HCA CLASSROOM BUILDING
1408 S. Goliad St. "BLDG C"
Rockwall, Texas 75087

PROJECT NUMBER: SP2023-025
PROJECT NAME: Site Plan for 1408 S Goliad Street
SITE ADDRESS/LOCATIONS: 1408 S GOLIAD ST

CASE CAPTION: Discuss and consider a request by Robert Howman of Glenn Engineering on behalf of Brad Helmer of Heritage Christian Academy for the approval of a Site Plan for a new building in conjunction with an existing Private School on a 6.64-acre parcel of land identified as Lot 1, Block A, Heritage Christian Academy Addition, City of Rockwall, Rockwall County, Texas, zoned Multi-Family 14 (MF-14) District, situated within the SH-205 Overlay (SH-205 OV) District, addressed as 1408 S. Goliad Street, and take any action necessary.

DEPARTMENT	REVIEWER	DATE OF REVIEW	STATUS OF PROJECT
PLANNING	Henry Lee	08/25/2023	Needs Review

HCA CLASSROOM BUILDING
1408 S. Goliad St. "BLDG"
Rockwall, Texas 75087
Project number 2023-014 Date 08/17/2023
SITE PLAN PHOTOMETRICS
Scale: AS NOTED

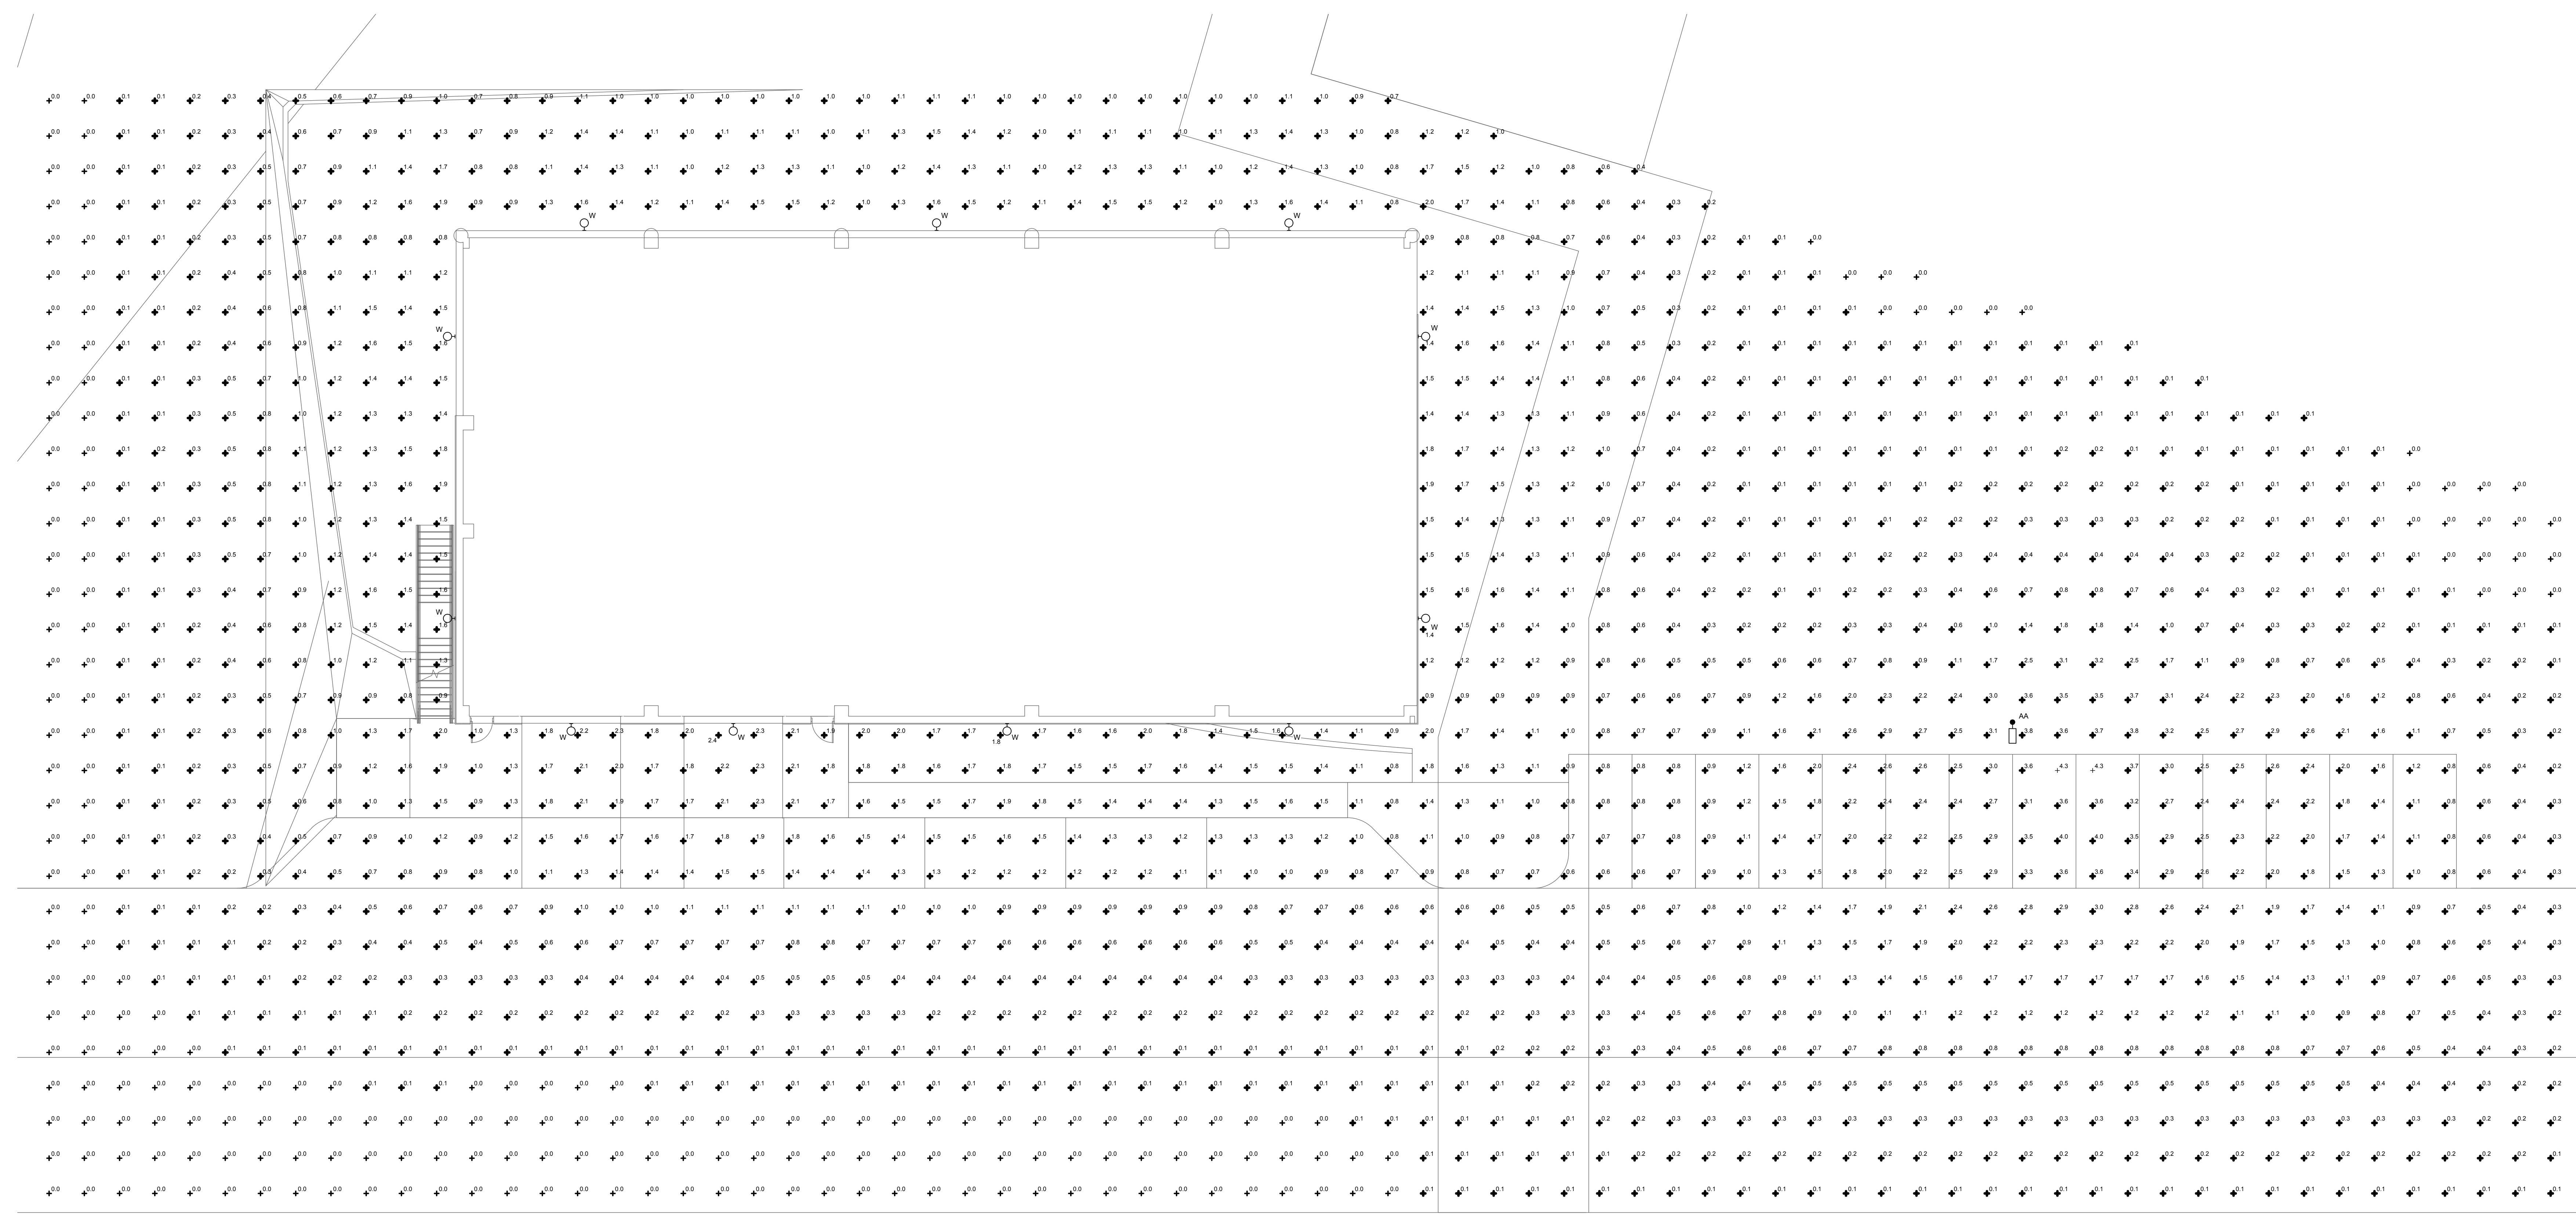
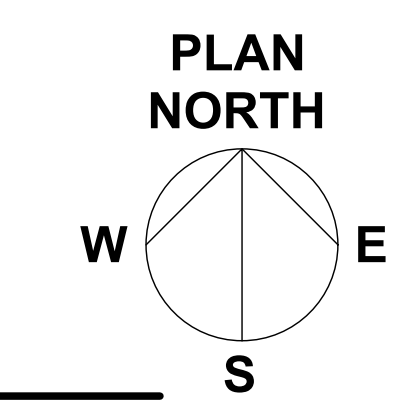
M.10 Photometric Plan:

- (1) Provide the same site data information required in Section 2.1 of the site plan checklist. (See Section 2.1 of the site plan checklist)
- (2) The 0.2 FC requirement exceeds at the S. property line. Please correct this. (Subsection 03.03. G, of Article 07, UDC)
- (3) No light pole, base or combination thereof, or wall pack shall exceed 20 feet. Please indicate the pole heights and mounting heights. (Subsection 03.03. D, of Article 07, UDC)
- (4) Please provide all lighting cutsheets and spec sheets. All lighting must be oriented downward and fully screened. (Subsection 03.03, of Article 07, UDC)

OVERALL
SITE PLAN
Sheet
C03.00

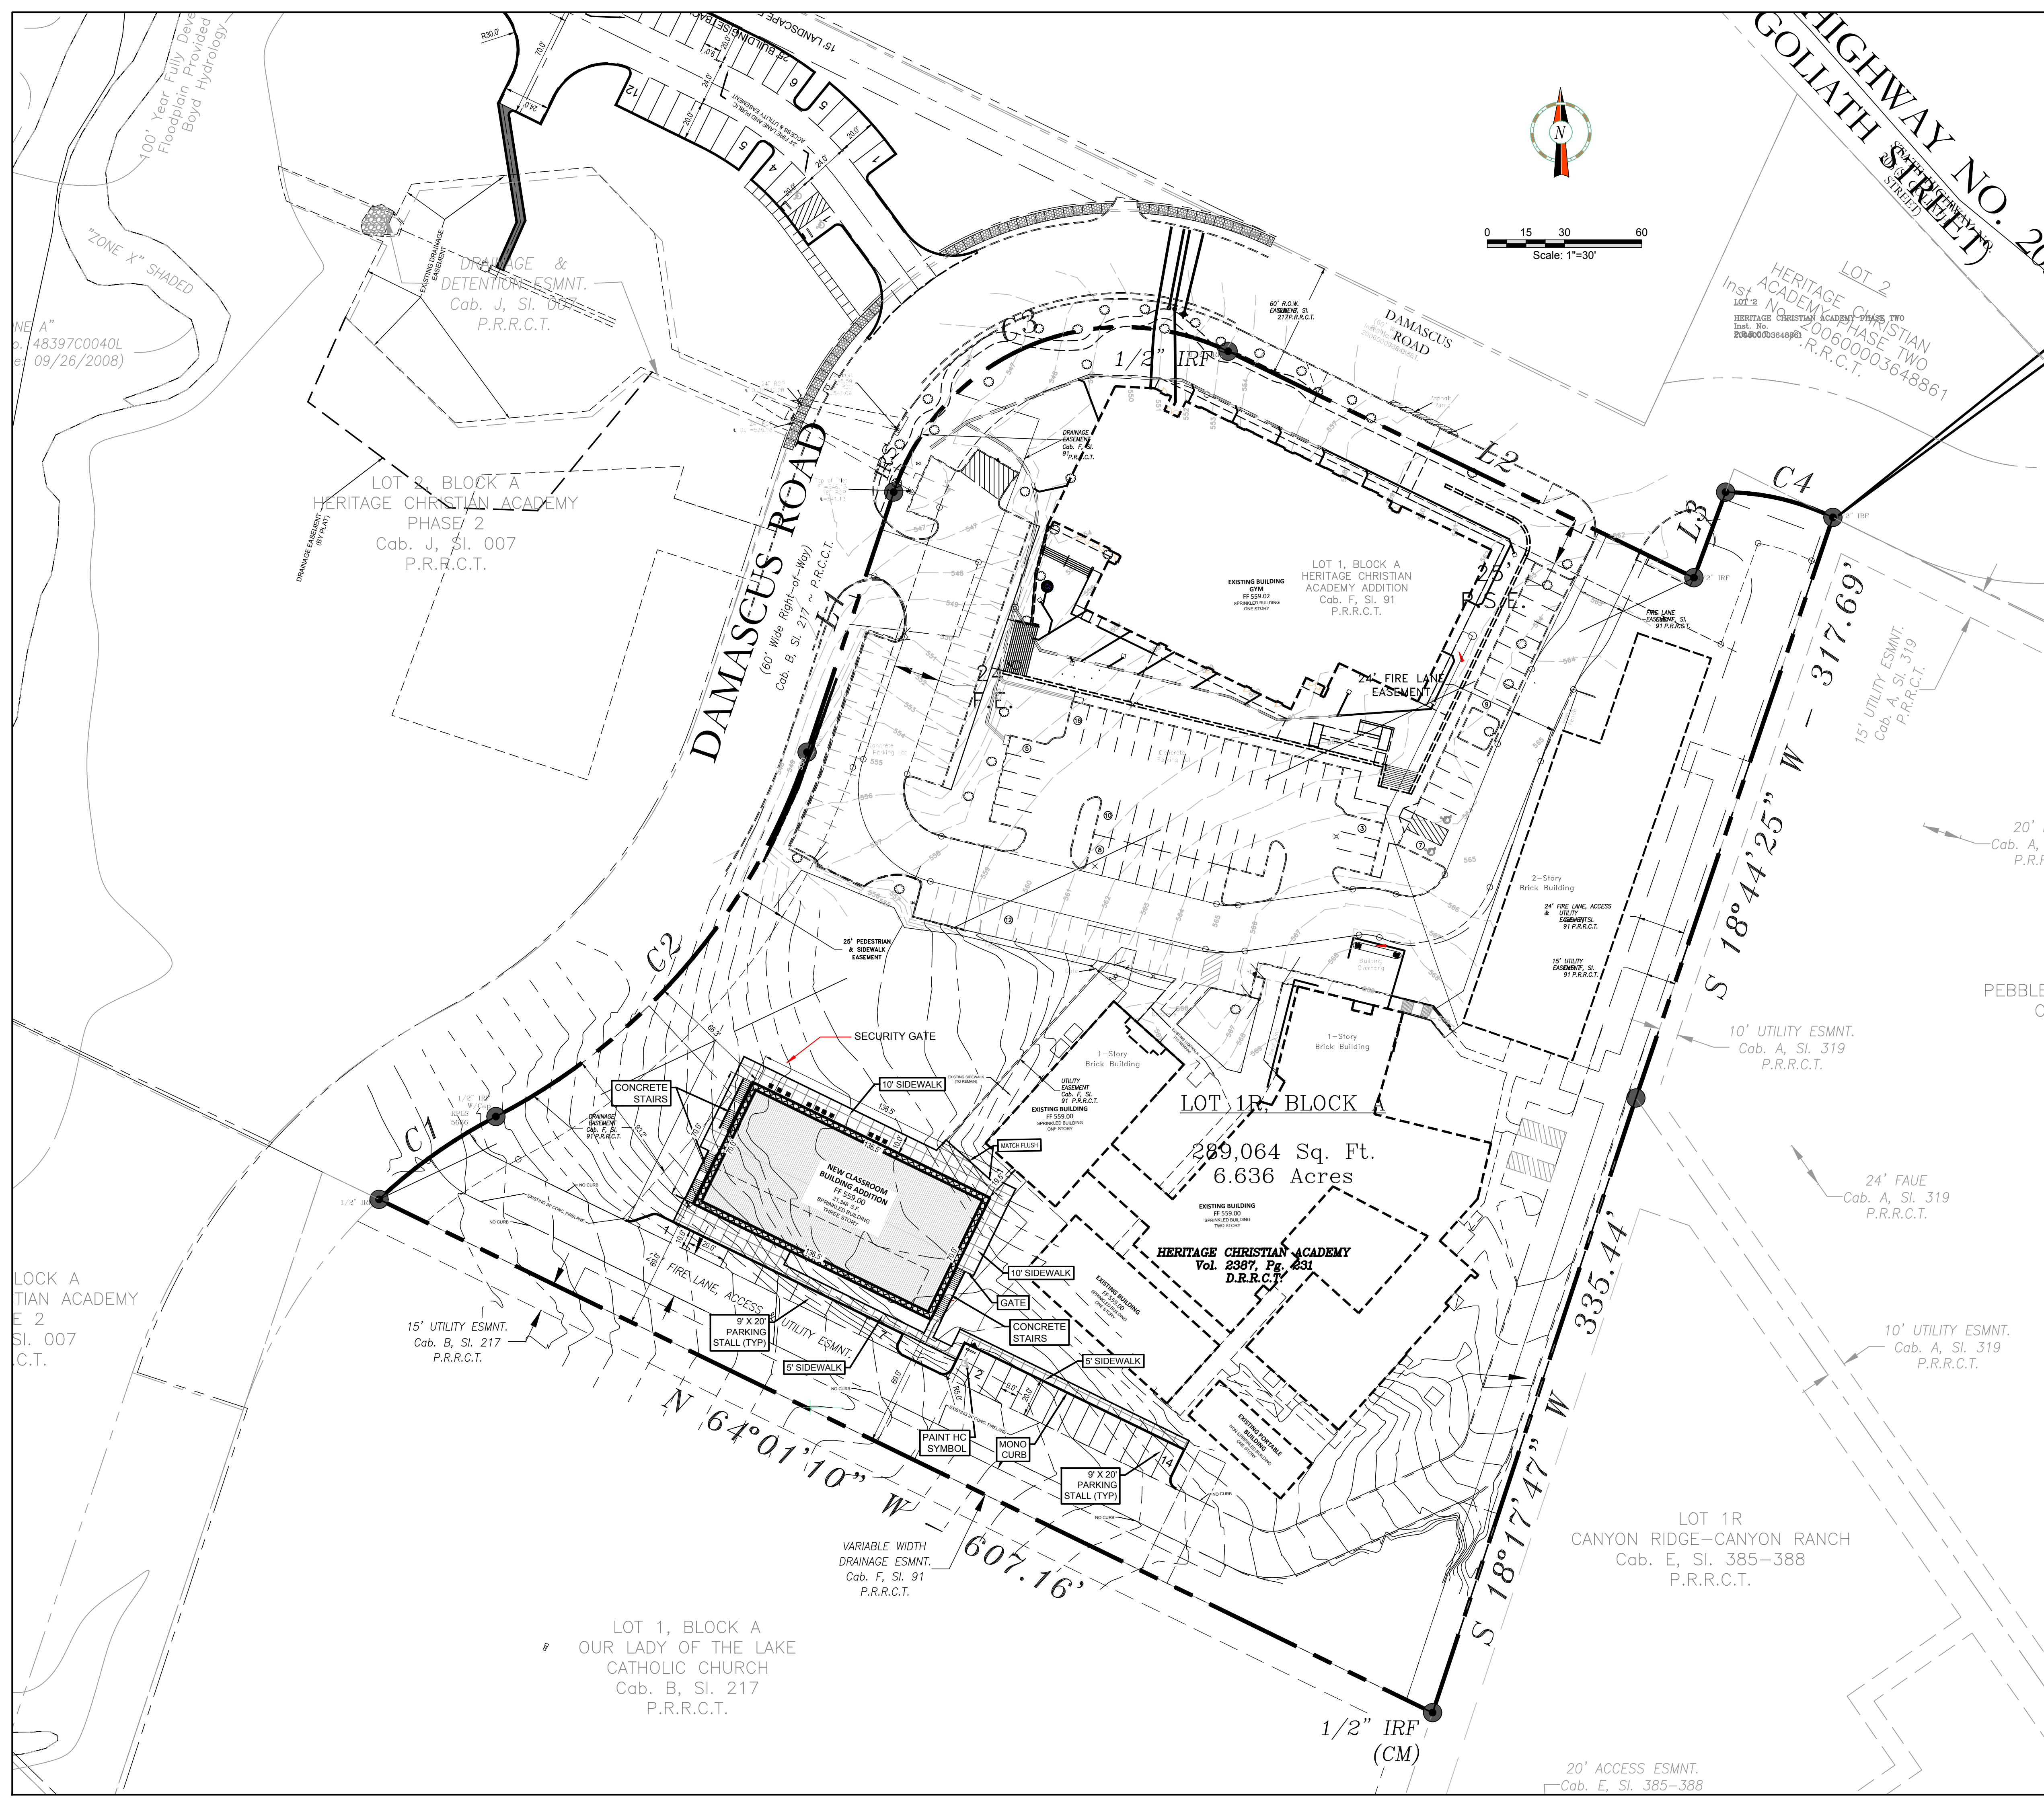
M.8 Site Plan:

- (1) Please clarify if all of the portables are to be removed. (Subsection 03.04. B, of Article 11, UDC)
- (2) Please correct the zoning callout to MF-14 not AG. (Subsection 03.04. B, of Article 11, UDC)

- (10) Please clarify if the existing dumpster will be used for this building. (Subsection 01.05. B, of Article 05, UDC)
- (11) Please indicate that there will be no outside storage. (Subsection 03.04. B, of Article 11, UDC)
